UNITED STATES PATENT AND TRADEMARK OFFICE

10/551,629

Office Action Summary	Application No. 10/551,629	Applicant(s) KOHDA, TORU	
	Examiner Jay R. Ripley	Art Unit 3679

DETAILED ACTION

(Meeske Figure 1 and Figure 2)

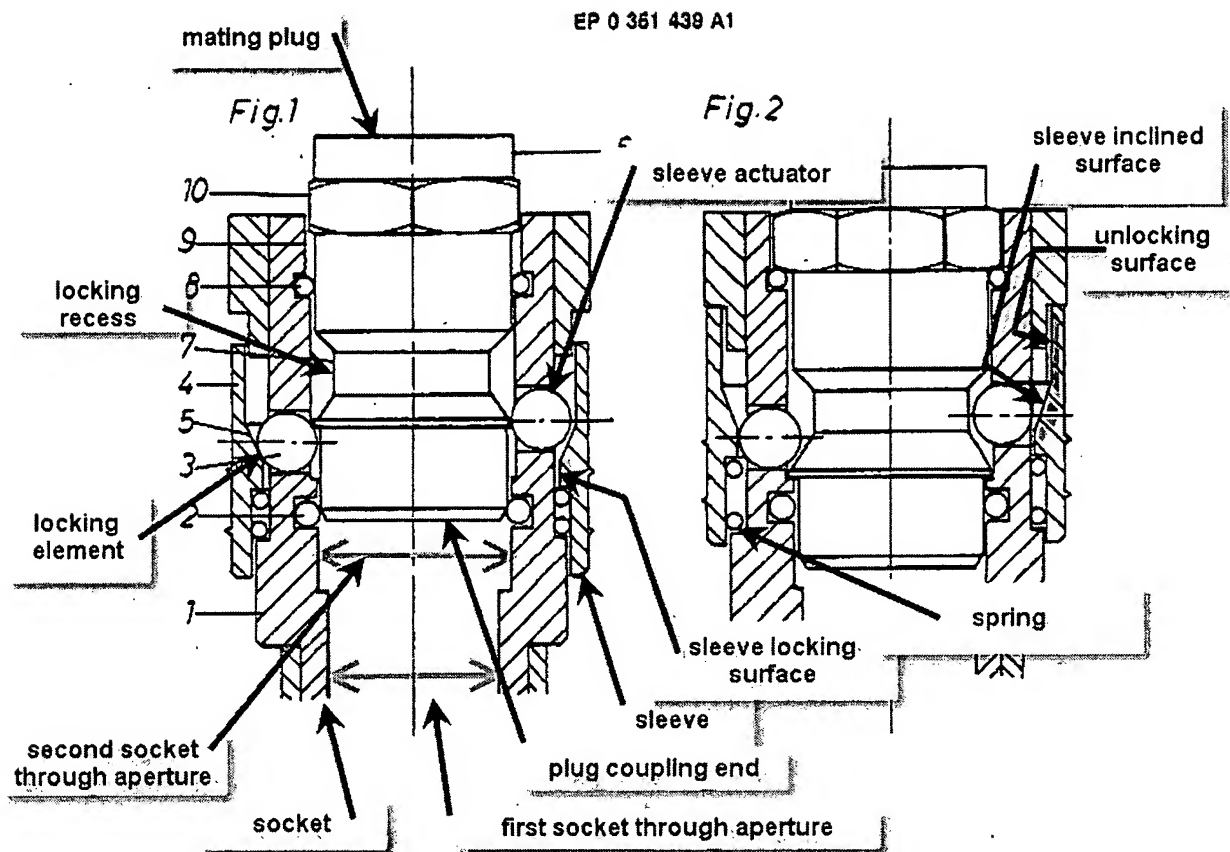
In regard to claims 3 and 8, Meeske discloses in Figure 1 and Figure 2, below, a pipe coupling comprising

a cylindrical socket body (1) having a first through aperture extending radially therethrough (as observed in Figure 1, below);

a locking element (the ball 3 furthest from the plug in Figure 1, below) radially movable within the first through aperture, the locking element being movable between a first radial position wherein the locking element is engaged with a locking recess (7) on the plug (as observed in Figure 2 and column 2, lines 31-35) so as to inhibit disconnection of the plug from the socket and a second radial position wherein the locking element is radially outwardly displaced from the first radial position and disengaged from the locking recess (as observed in Figure 1) to allow disconnection of the plug from the socket;

a sleeve (4) disposed around the socket body and having a locking surface (as observed in Figure 1, below) adapted to hold the locking element against radial outward movement (as observed in Figure 1, below) and prevent movement of the locking element from the first radial position to the second radial position and an unlocking surface adapted to allow movement of the locking element from the first radial position to the second radial position, the sleeve being axially movable (as observed when comparing Figure 1 and Figure 2) between a locking position wherein the locking surface is positioned radially outwardly of the locking element and an

a spring (as observed in Figure 1, below) for biasing the sleeve toward the locking position,

the socket body comprises a second through aperture (as observed in Figure 1, below) located axially closer to the plug than the first through aperture and extending radially therethrough and a sleeve actuator (as observed in Figure 1, below) disposed in the second through aperture and movable between a radially inward position wherein the sleeve actuator is engaged with the coupling end of the plug upon insertion of the plug into the socket and a radially outward position wherein the sleeve actuator is located radially outwardly from the radially inward position (as observed in Figure 1, below); and

the sleeve has an inclined surface (as observed in Figure 1, below) inclined radially outwardly from the locking surface toward the unlocking surface, the inclined surface being engaged with the sleeve actuator when the sleeve is located in the locking position, the coupling end of the plug being engaged with the sleeve actuator upon insertion of the plug into the socket so that the sleeve actuator is radially outwardly moved to thereby cause axial movement of the sleeve against the bias of the spring and, thus, when the coupling end of the plug is brought into engagement with the locking element during advancement of the plug, the inclined surface is positioned at a radially outward position relative to the locking element, the coupling end of the plug radially outwardly urging the locking element against the inclined surface of the sleeve upon further insertion of the plug, thereby causing further axial movement of the sleeve (the invention of Meeske has the structure to so perform the functional recitation as can be observed in Figure 1 and Figure 2, below).

Meeske discloses the claimed invention except for the sleeve comprising two sleeve elements and a stopper feature. Wayne teaches a pipe coupling with locking elements (6, 7) in Figure 1, below, wherein the sleeve comprises two elements (5, 8) to provide a quick disconnection of the coupling with a releasable locking sleeve (column 1, lines 38-41). As Wayne relates to pipe couplings with locking elements, it would have been obvious to one having ordinary skill in the art at the time the invention was made to modify the pipe coupling of

(Wayne Figure 1)

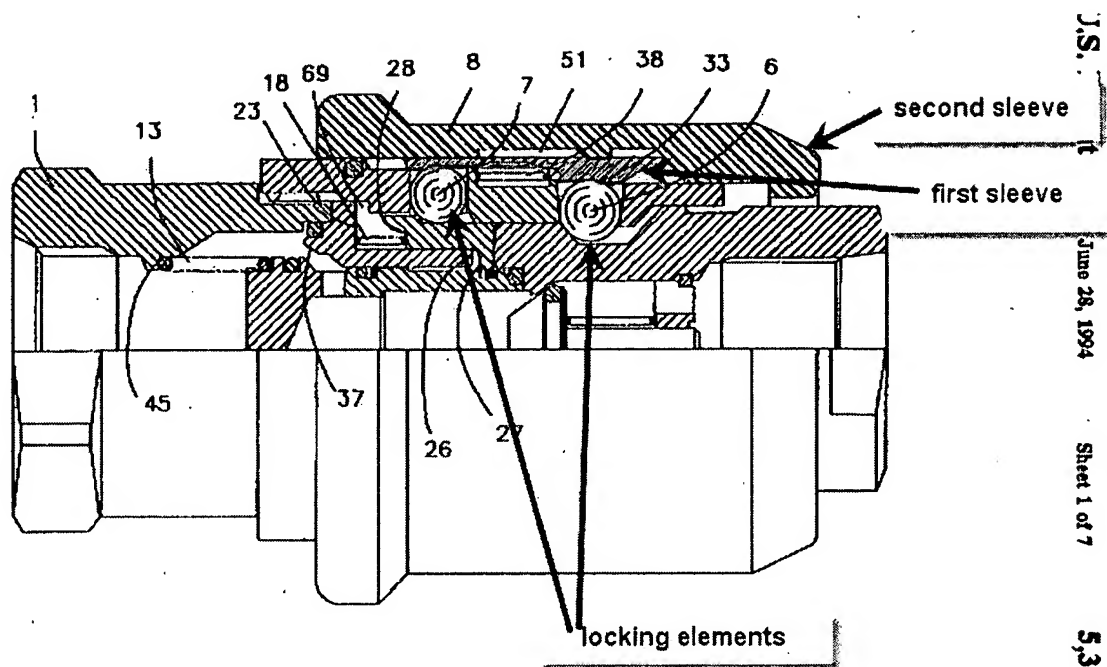
Meeske with the sleeve comprising two sleeve elements as taught by Wayne to provide a quick disconnection of the coupling with a releasable locking sleeve.

(Mullins Figure 6 and Figure 7)

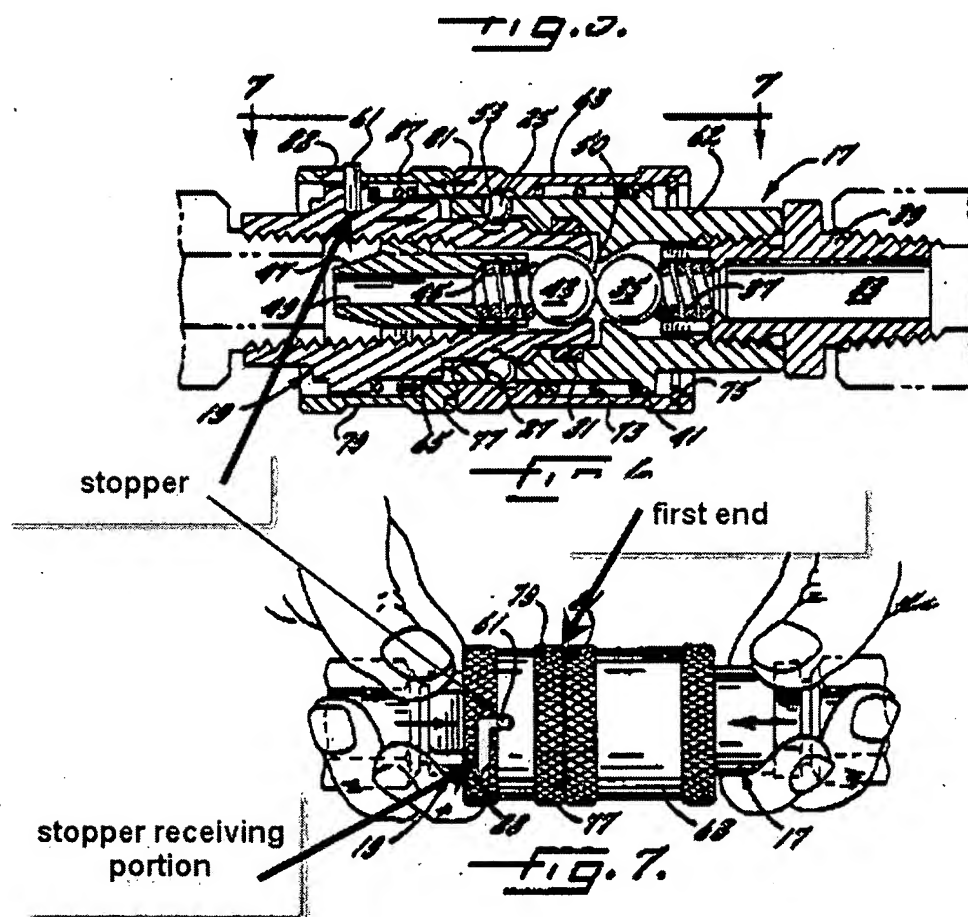
Further in regard to claims 3 and 8, Meeske in view of Wayne provide for the claimed invention except for a stopper feature. Mullins teaches a pipe coupling with locking elements in Figure 6 and Figure 7, below, with a stopper structure (pin 61 and slot 88) arranged on a coupling member, the stopper allowing a spring biased sleeve (79) to rotate between two angular positions and prevent axial movement of the sleeve at one of the axial positions (column 7, lines 48-52), to substantially preclude inadvertent uncoupling of the plug and the socket from coaxial relation (column 7, lines 45-52). As Mullins relates to pipe couplings with locking

elements, it would have been obvious to one having ordinary skill in the art at the time the invention was made to modify the sleeve as provided for by Meeske in view of Wayne with the stopper structure as taught by Mullins to substantially preclude inadvertent uncoupling of the plug and the socket from coaxial relation

In regard to claims 6, 9, 10, and 11, Mullins, in Figure 6 and Figure 7, above, provides:
the sleeve (79) having a first end adjacent to the plug (19) and a second end remote from the plug,

wherein the stopper receiving portion includes a slot (88) extending from the second end toward the first end of the second sleeve,

wherein the stopper (61) extends radially outwardly from the fitting (as observed in Figure 6)

(Wayne cut-out of Figure 1)

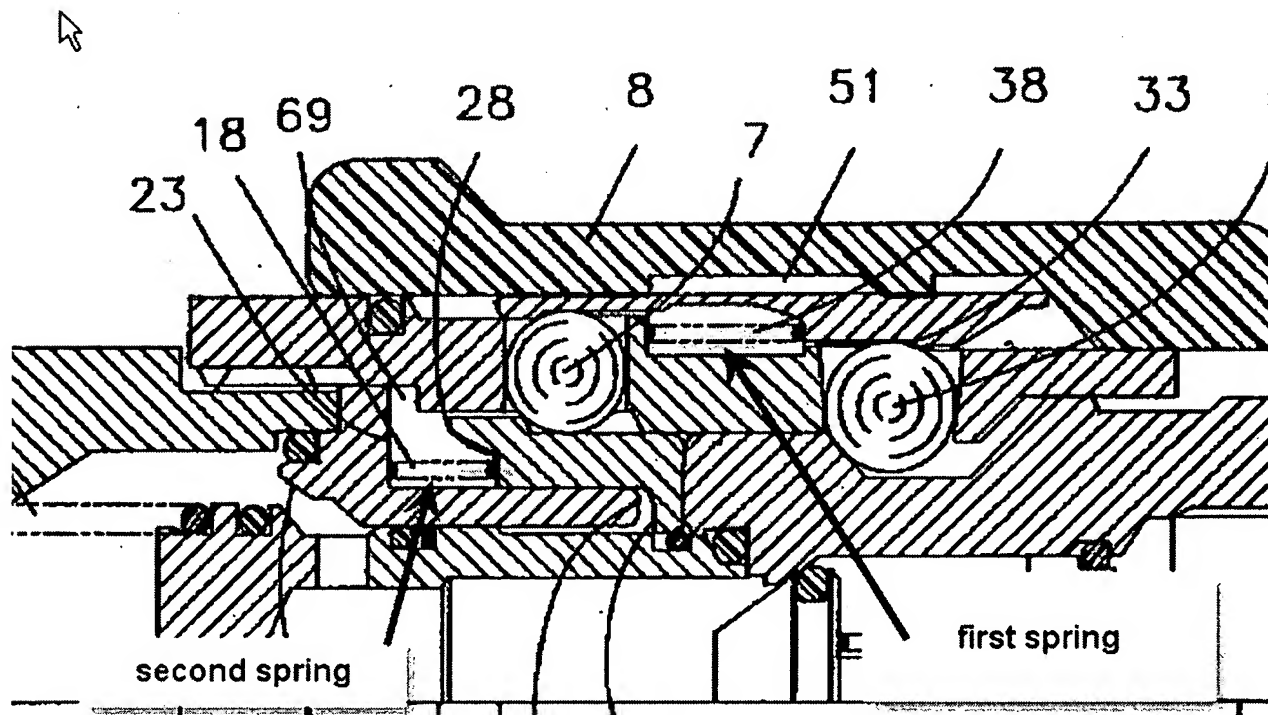
In regard to claim 4, Meeske in view of Wayne and Mullins provide for the claimed invention including a second spring. Wayne also teaches a second spring (18), as observed in cut-out of Figure 1, below, to urge the sleeve toward the locked position (column 4, lines 18-20). As Wayne relates to pipe couplings with locking elements, it would have been obvious to one having ordinary skill in the art at the time the invention was made to further modify the pipe coupling as provided by Meeske in view of Wayne and Mullins with a second spring as further taught by Wayne to urge the sleeve toward the locked position.

(Meeske cut-out of Figure 1)

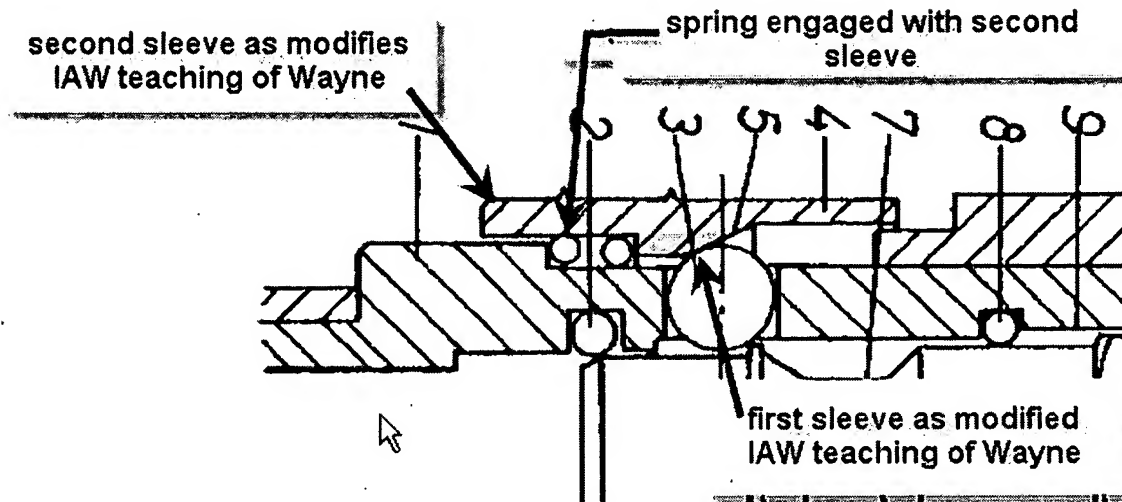
In regard to claim 5, Meeske further provides for a coil spring disposed around the socket body having one end located at one position on the socket body and engaged with the first sleeve to urge the first sleeve toward the locking position, and an other end engaged with the second

sleeve (a coil spring as indicated by the symbol used in Meeske Figure 1, a cut-out shown below, the recognized technical drafting symbol for a coil spring).
